Product Change Notification

Product Group: Vishay Siliconix/May 23, 2014/PCN-SIL-0102014 Rev 0

Qualification of ASE as an Additional Assembly Site of TO-220 Commercial Power Mosfets

Outline Drawing

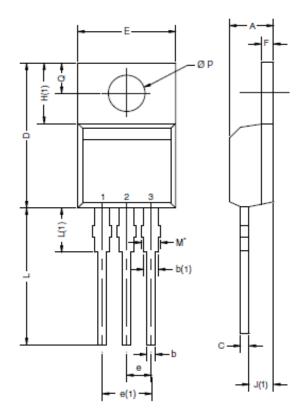
Additionally, there will be slight modifications to the mechanical dimensions of the TO-220 Package Outline. The updated TO-220 package outline drawing is exhibited below in this PCN.

DIM (inches)	JEDEC		Current		Revised (Updates in BOLD)		Change
	Min.	Max.	Min.	Max.	Min.	Max.	580
Α	0.140	0.190	0.167	0.183	0.163	0.185	-0.004/+0.002
b	0.015	0.040	0.027	0.040	0.027	0.040	None
b(1)	0.045	0.070	0.047	0.068	0.045	0.068	-0.02
С	0.014	0.024	0.014	0.024	0.014	0.024	None
D	0.560	0.650	0.585	0.610	0.564	0.624	-0.021/+0.014
E	0.380	0.420	0.395	0.414	0.392	0.414	-0.003
е	0.100 BSC		0.095	0.105	0.095	0.105	None
e(1)	0.200 BSC		0.192	0.208	0.192	0.208	None
F	0.020	0.055	0.045	0.055	0.017	0.055	-0.028
H(1)	0.230	0.270	0.240	0.255	0.240	0.264	+0.009
J(1)	0.080	0.115	0.095	0.115	0.095	0.115	None
L	0.500	0.580	0.526	0.552	0.526	0.567	+0.015
L(1)		0.250	0.131	0.150	0.131	0.159	+0.009
¢ P	0.139	0.161	0.139	0.155	0.139	0.155	None
Q	0.100	0.116	0.102	0.118	0.100	0.118	-0.002
*M	None		0.052	0.064	0.052	0.064	None
